ISB RFI #020

ISB RFI #029

Figure 5. Generic vibration criterion NIST-A curve for critical areas in nanotechnology facilities. Several of the VC criteria are shown for reference.

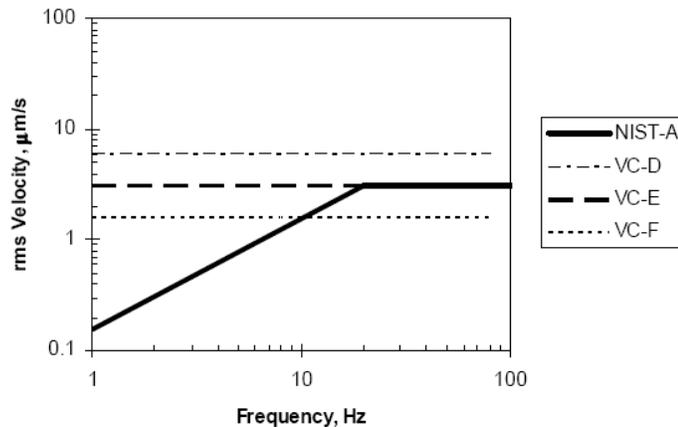
11. At the request of one of the Air Spring manufacturers, please provide a manufacturer and model # for the owner furnished/ owner installed STM. If this is not available please provide vibration criteria for same.
 - a. The Owner provided STM is a custom unit, and vibration criteria are not available for publication.
 - b. Design criteria for the isolation block is the NIST A curve, shown in the following chart:

Criterion	Definition
NIST-A	0.025 μm or 25 nm (1 μin) between 1 and 20 Hz; 3.1 $\mu\text{m/s}$ (125 $\mu\text{in/s}$) between 20 and 100 Hz
VC-D	6.25 $\mu\text{m/s}$ (250 $\mu\text{in/s}$) between 1 and 80 Hz
VC-E	3.1 $\mu\text{m/s}$ (125 $\mu\text{in/s}$) between 1 and 80 Hz
VC-F	1.6 $\mu\text{m/s}$ (62.5 $\mu\text{in/s}$) between 1 and 80 Hz
